Access Compliance Report Public Rights-of-Way (Curb Ramps)

Main Street: AMIES_RD Cross Street: CHANTICLEER_RD Location: NE

ADA ID: RPRK210923120953 Ramp Type: Type 1 - Perpendicular Diagonal Initial Pass/Fail: Fail Overall Compliance: No Severity Score: 16

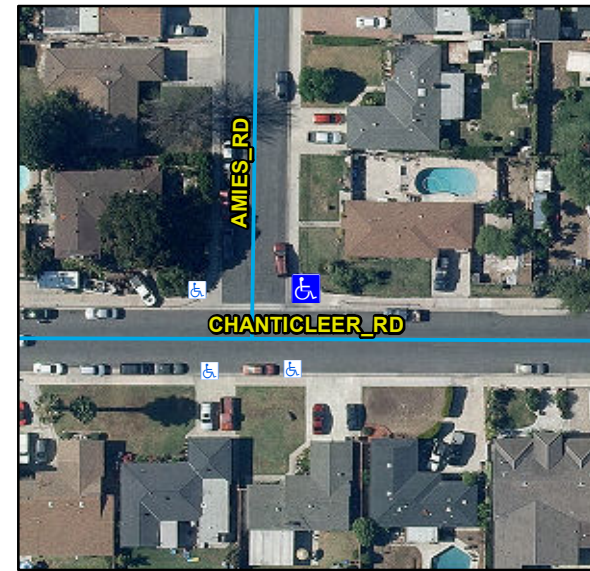
Compliance	Description	Data	Compliance	Description	Data
N/A	Ramp Length (in)	48	N/A	Flare Type LT	
Yes	Ramp Width (in)	48			N/A
No	Ramp Run Slope (%)	10.7	N/A	Flare Slope LT (%)	N/A
Yes	Ramp Cross Slope (%)	1.3	N/A	Flare Traversable LT	N/A
N/A	Landing Present	N/A	N/A	Flare Type RT	
N/A	Landing Length (in)	N/A			N/A
N/A	Landing Width (in)	N/A	N/A	Flare Slope RT (%)	N/A
N/A	Landing Run Slope (%)	N/A	N/A	Flare Traversable RT	N/A
N/A	Landing Cross Slope (%)	N/A	N/A	DWS Provided	N/A
N/A	Landing Movement Obstructed?	N/A	N/A	DWS Contrast	N/A
	Landing Movement Type	N/A	N/A	DWS Length (in)	N/A
N/A	Landing Shared	N/A	N/A	DWS Full Width	N/A
N/A	Clear Space	Yes	N/A	DWS Offset Left (in)	N/A
N/A	Clear Space To Crosswalk (in)	N/A	N/A	DWS Offset Right (in)	N/A
N/A	Marked Crosswalk 1	No	N/A	Marked Crosswalk 2	No
	Crossing 1 Direction	W		Crossing 2 Direction	S
	Marked Crosswalk 1 Width (in)	N/A		Marked Crosswalk 2 Width (in)	N/A

N/A	Ramp Inside Crosswalk 1	N/A	Yes	Ramp Inside Crosswalk 2	N/A
	Crossing 1 Slope (%)	3		Crossing 2 Slope (%)	2.8
	Crossing 1 Cross Slope (%)	2.5		Crossing 2 Cross Slope (%)	0.3
N/A	Gutter Ponding	N/A	No	Curb Slope	5.6
No	Gutter Lip Height (in)	0.25		Road Run Slope (%)	0.6
N/A	Gutter Run Slope (%)	N/A		Road Cross Slope (%)	3.3
N/A	Gutter Cross Slope (%)	N/A			
Yes	Overall Surface Condition: Acceptable		No	Perp Joint Present	No
	Cross Gutter Present?	Yes		Spandrel Present?	Yes
	Replace Cross Gutter?	No		Replace Spandrel?	No

Possible Solutions:
Remove & Replace Curb Ramp With Two New Directional Ramps or Equivalent.

OC Std/PROW:
R304.2.2, R204.3, R302.7.2, STD 1115
